# **Official Transcript of Proceedings**

## **NUCLEAR REGULATORY COMMISSION**

Title:                   Advisory Committee on Reactor Safeguards  
                              Regulatory Policies and Practices

Date:                  Wednesday, October 18, 2017

**Figure I-1 Cumulative pressurizer safety valve open area fraction versus total number of safety valve cycles, where early containment failures are shown in red\*\***

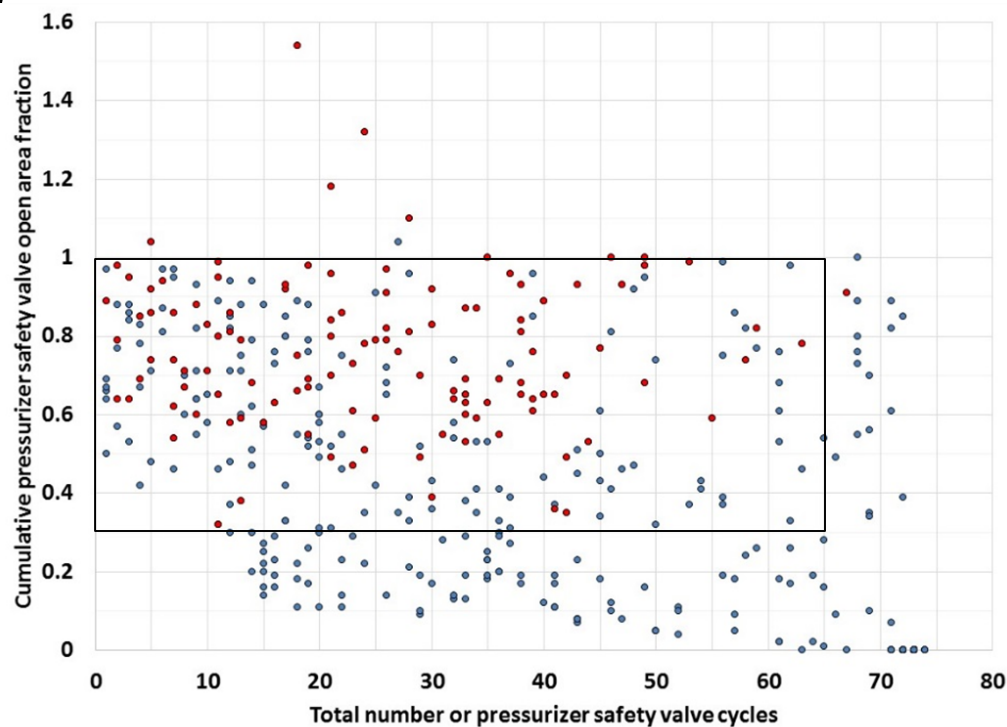
15                  In particular, I look at your fifth-order  
16       polynomial fit to the valve failure rate for the valve  
17       data in Figure I-2.

18 The second part of it is when you do the  
19 differentiation of that curve to get the density  
20 function in Figure I-3, that density function does  
21 indeed start out at 1.83e to the -3, at a value of 1.

1           So, I want to make sure that the actual  
2           sampling used the correct probability for failure on  
3           the first demand, that it didn't use 1.83e to the -3,  
4           that it used something between 2 and 3e to the -2 in  
5           the actual runs that you made.

11 MEMBER BLEY: Just maybe Figure I-3, which  
12 is the density function, was drawn without showing the  
13 delta function either.

16 MEMBER BLEY: Maybe it's just the way you  
17 drew the Figure, and you didn't show that three minus  
18 two, right, at one.

21                   MS. GHOSH: So, I think we're going to  
22 take your comment and re-check the numbers after this  
23 meeting, because we're not going to be able to resolve  
24 it right here.

13 MS. GHOSH: But I think in terms of the  
14 larger question of the exact numbers, we'll have to  
15 get back to you on that and we'll double-check.
